# MORGANTOWN PLANNING COMMISSION

## **STAFF REPORT**

**CASE NO:** S14-01-III / CA Student Living / 494 Spruce Street

Request by Lisa Mardis of Project Management Services, on behalf of CA Student Living, for Development of Significant Impact Type III Site Plan approval of a mixed-use development at 494 Spruce Street

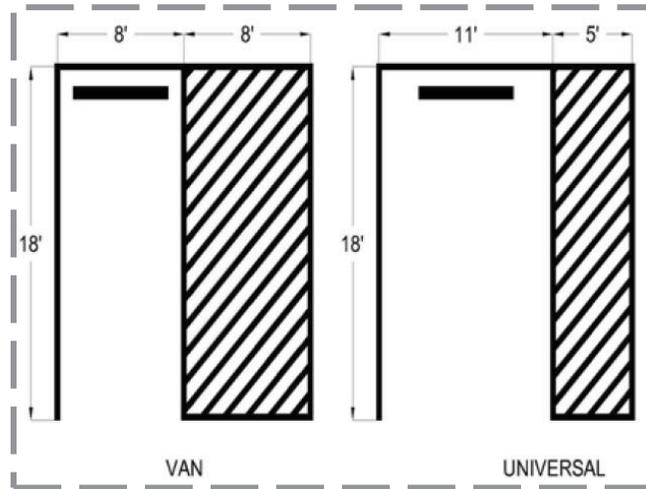
- (1) Concerning “Curb Cut” standards provided under Article 1351.01(D), agreement on the points of tangency for the driveway flares must be achieved so that the extent of requisite variance relief, as currently designed, can be identified.

As discussed with Mr. Carl Emberger this day, modification of the driveway “flares” to meet the maximum 26-foot standard provided under Article 1351.01(D) would eliminate variance relief in terms of width and in terms of proximity to the Spruce – Willey intersection. The City Engineer’s Office has agreed to model and compare the proposed design and the Article 1351.01(D) standards and advise the undersigned and the project’s design professionals accordingly. However, a final decision from the project’s design team is necessary on whether the presently designed driveway “flares” will be pursued or modified to conform with related standards.

Regardless of whether the present design or modified conforming design is pursued, please submit an inset drawing or separate sheet (hard copy) to this office no later than FRI 25 APR 2014 that identifies and labels the relational dimensions and distances between “true” points of tangency and the five (5) performance standards provided under Article 1351.01(D).

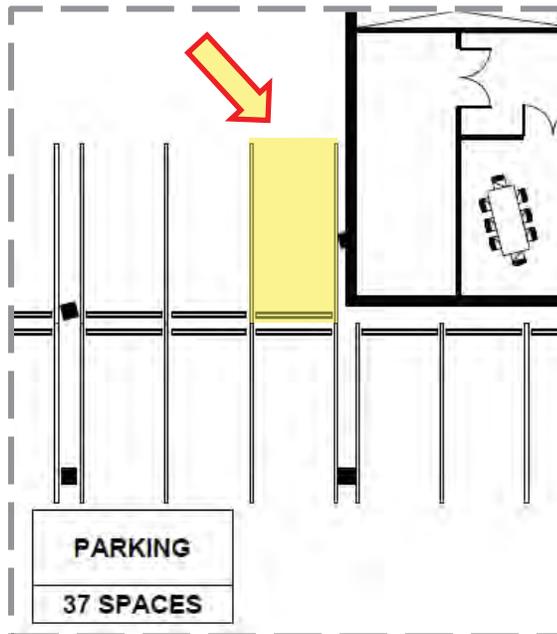
- (5) The following graphic is clipped from Sheet Z0.02 illustrating a portion of the Level 01 Floor Plan. The parking space highlighted in yellow should be designed and managed as a compact space to ensure sufficient depth for maneuvering.

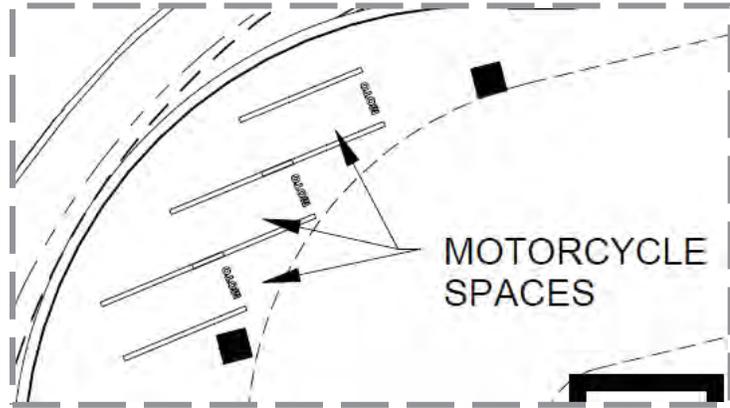
- (7) 3D simulation of the building in the existing built environment will be required for presentations to the Planning Commission, and the BZA to better inform massing, scale, density, and context. Capturing taller nearby buildings (e.g., Unity Manor, WVU’s Arnold Hall, Metro Property’s Courtyard East and West Buildings, etc.) will be critical to visualizing scale and massing context. The electronic presentation (i.e., PowerPoint) to the Planning Commission and BZA that, which includes building renderings and 3D simulation, will become a part of the public record. As such, an electronic copy (PDF) must be provided to Planning Division the night of the respective hearings.
